Planning and Strategy Committee of the Whole

10 May 2017

ITEM 4.3 DEVELOPMENT APPLICATION 519-2016 - DUAL
OCCUPANCY - 14 ARTHUR STREET, CRESTWOOD

ITEM 4.4 DEVELOPMENT APPLICATION 5-2017 - ERECTION OF A
GARAGE AT 52 ROSS ROAD QUEANBEYAN

ATTACHMENT 2 DA 5-2017 - 52 ROSS ROAD, - ERECTION OF A GARAGE -
PLANS

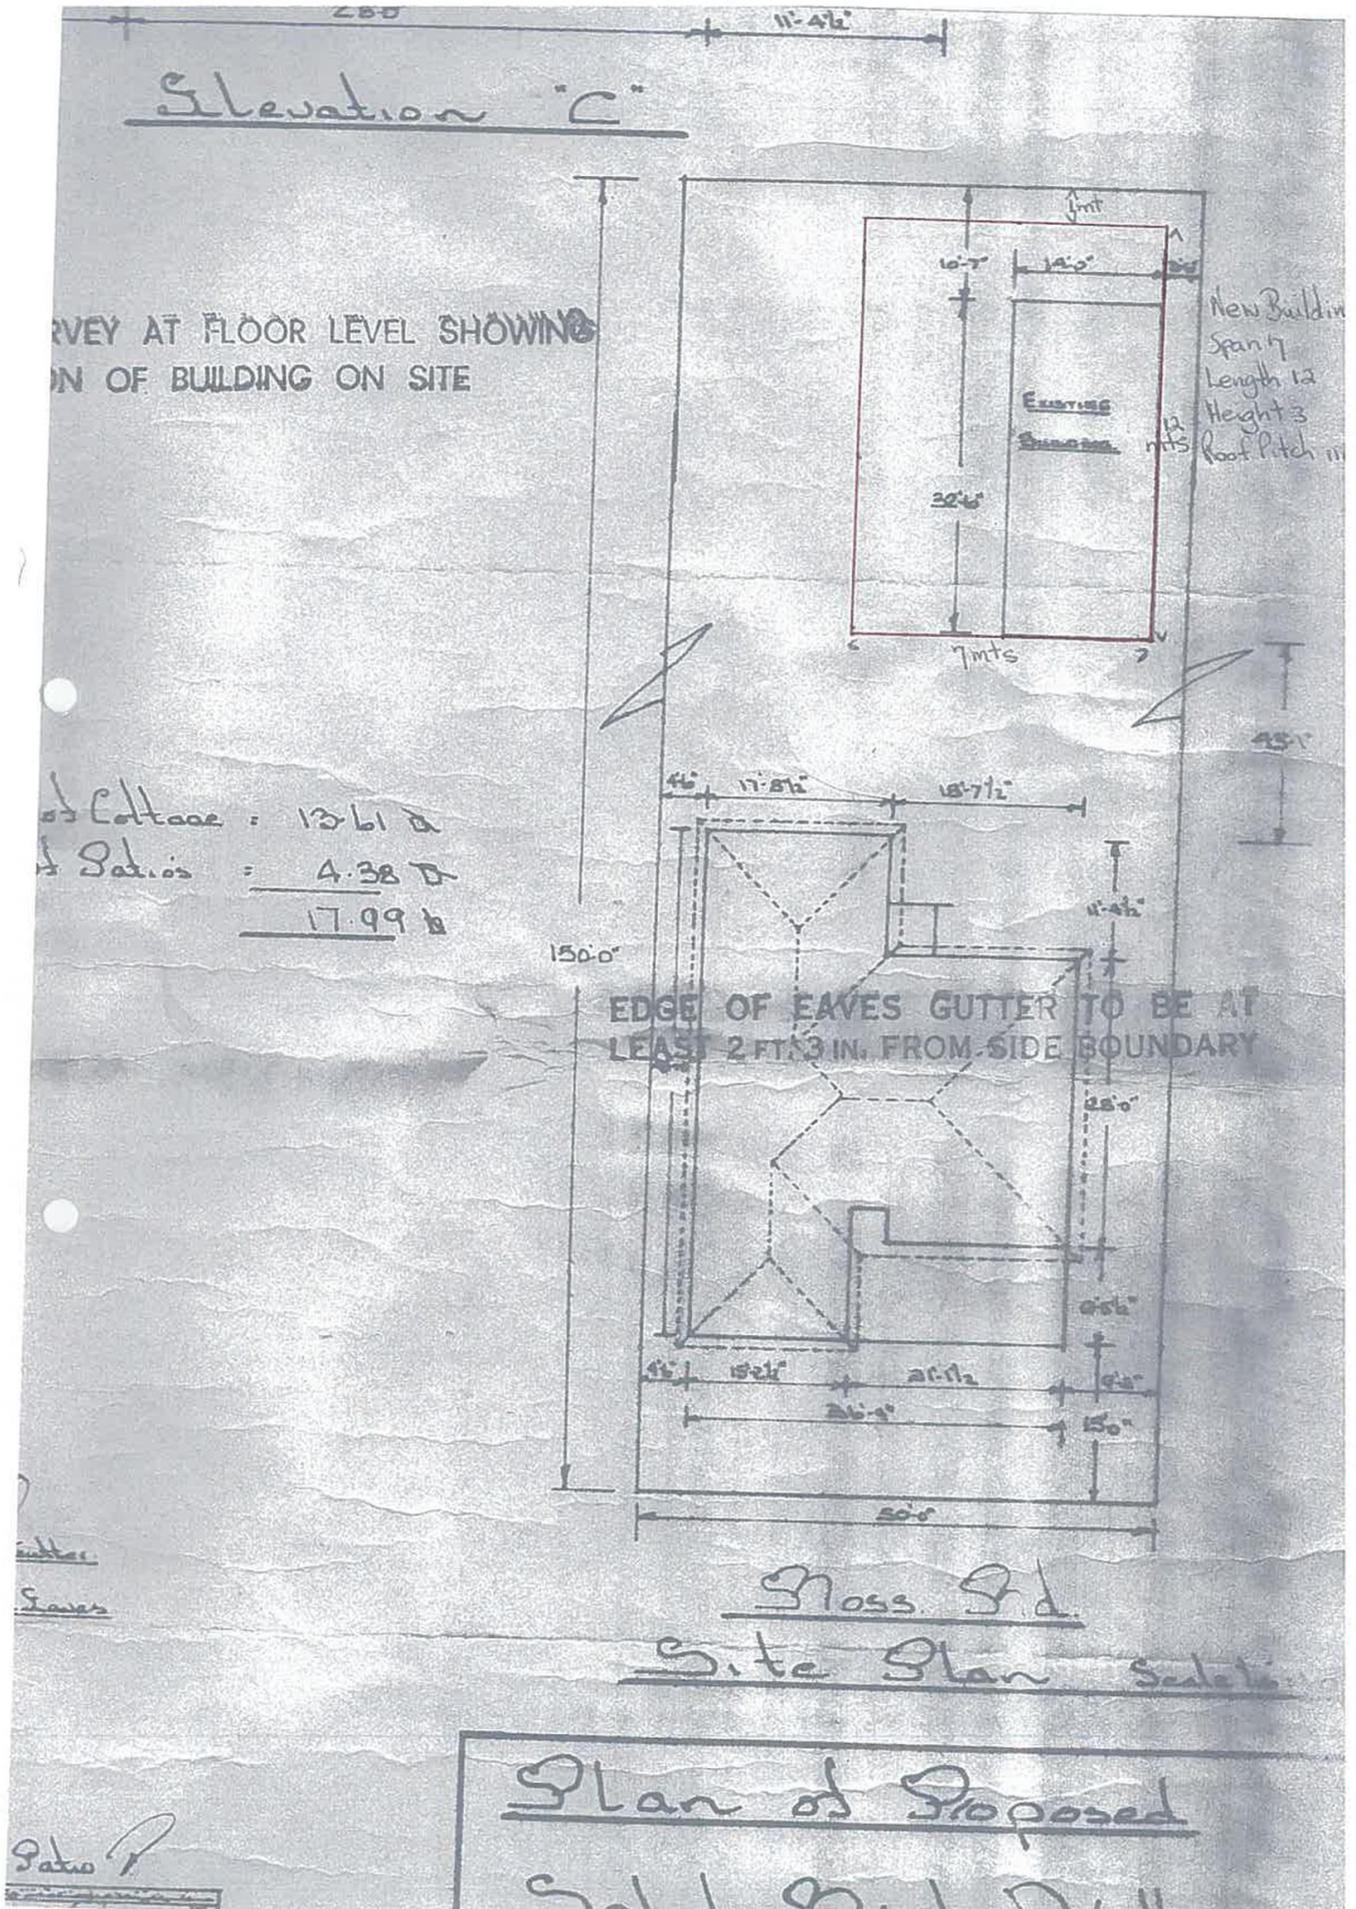
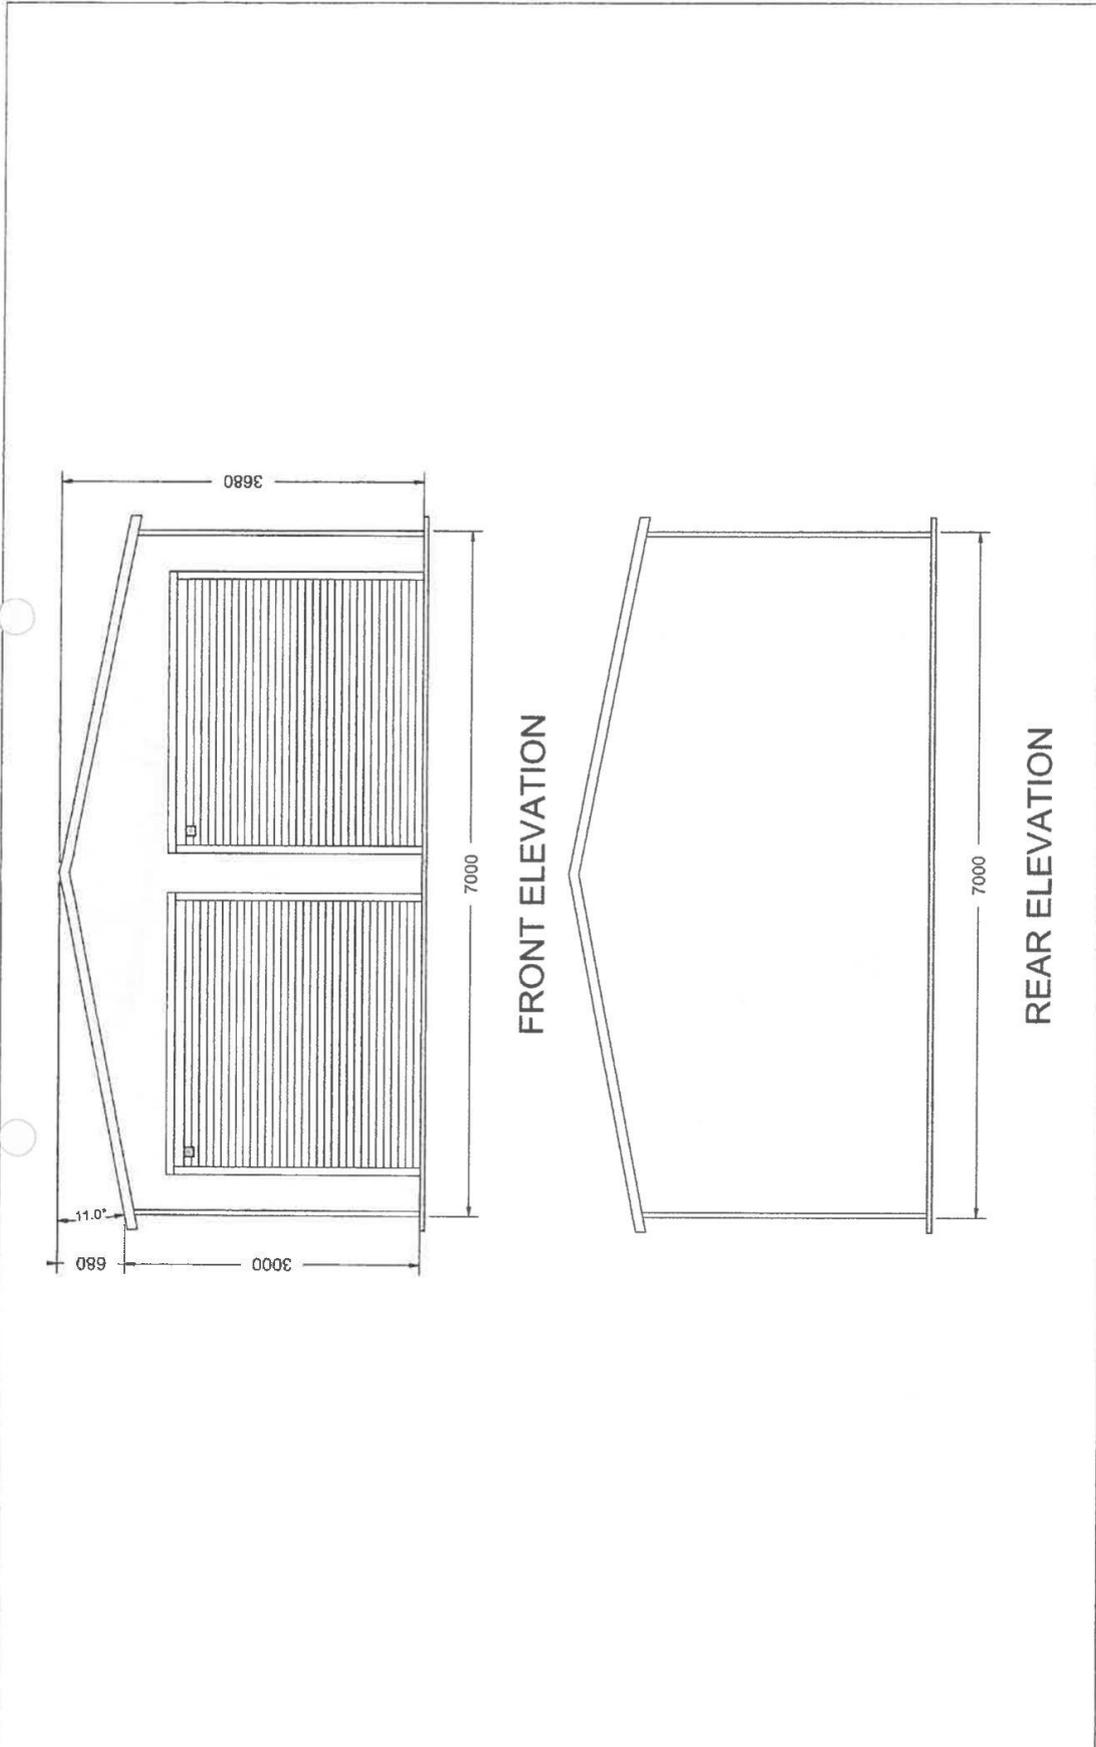
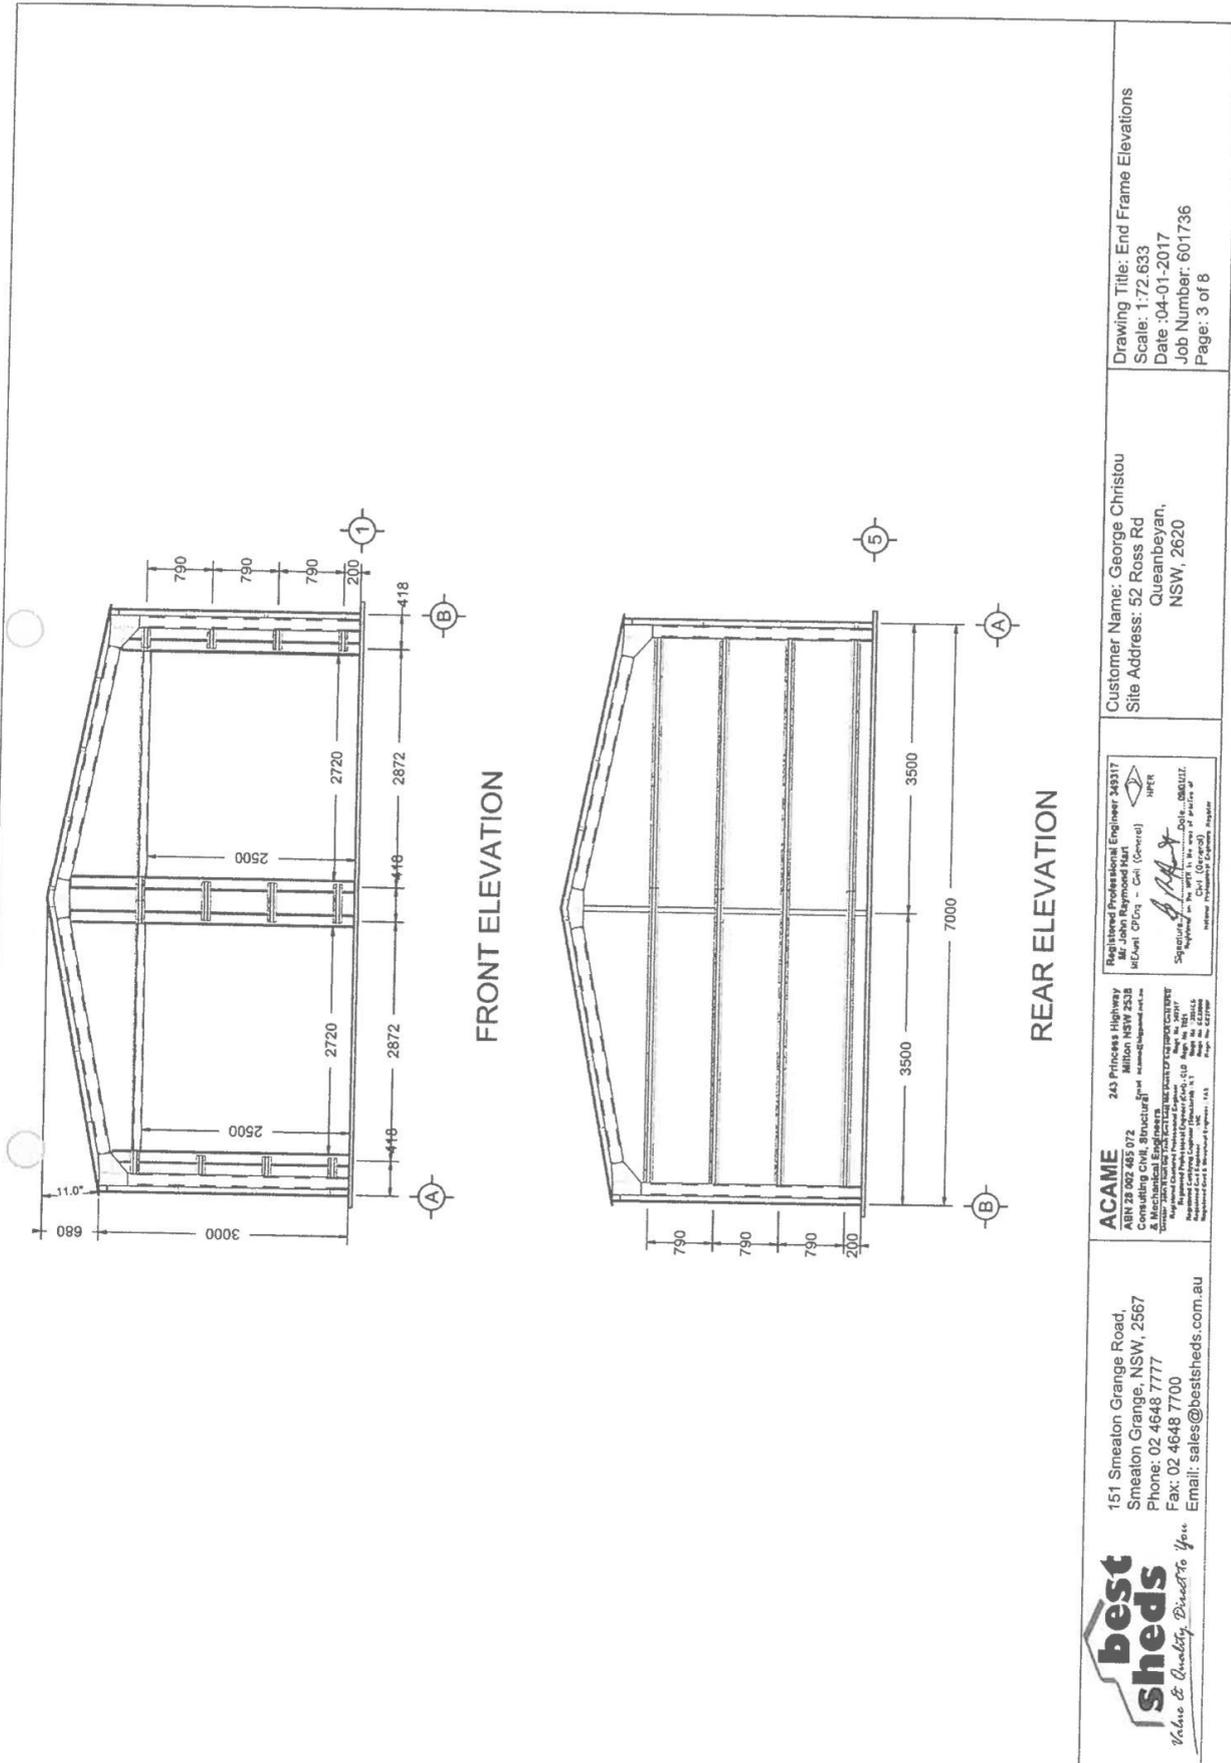
QUEANBEYAN DCP 2012 COMMENTS	COMPLIES (Yes/No)
<p><i>similar to those in the adjacent dwelling.</i></p> <p><i>k) Garage walls shall be no higher than 2.4m above ground level.</i></p> <p>The proposed garage walls are 3 metres in height.</p> <p><u>Variation to Development Control Plan</u></p> <p>The proposed development has a wall height of 3 metres. The requirement for garages in the heritage conservation area is a maximum wall height of 2.4 metres, under <i>Part 4 – Heritage, Metal Garages – Specific Controls, Clause 4.4.2 k) of the DCP.</i></p> <p>Applicant’s justification</p> <p>In support of the proposed variation the applicant has put forth their reasons to support the variation, which include:</p> <ul style="list-style-type: none"> • The large setback distance from the front boundary, • The visual impact on the surrounding area, which is minimal as a result of the setback and the location of the garage at the rear of the property. • The house is not a heritage item. <p>Assessing Officer’s Comments</p> <p>The applicant’s justification for the variation to the height is generally supported. The proposed garage is setback at least 26 metres from the front boundary and only a portion would be visible from the street. As a result there would be minimal impact on the streetscape and character of the surrounding area. Additionally, variations to the height limit in the heritage conservation area have been supported in the past. There are examples of garages within the surrounding streets of the proposed development which have a wall height over the maximum 2.4 metres, with the most common variation being 2.7 metres or a 300mm variation.</p> <p><i>l) Development Application drawings should note the detail of the above items as well as wall height and colour.</i></p> <p><i>m) The colour of walls, roof, doors and trim shall match or be compatible with those of the principal building.</i></p> <p>Refer to comments against ‘New Garage clause 4.4.2 e)’ above.</p>

1. GARAGE TO ERECTED CLEAR OF EXISTING SEWER MAIN
Prior to the issue of a construction certificate (Building) the applicant shall provide to the accredited certifier a survey plan showing that the proposed development can be erected clear of the existing sewer main.
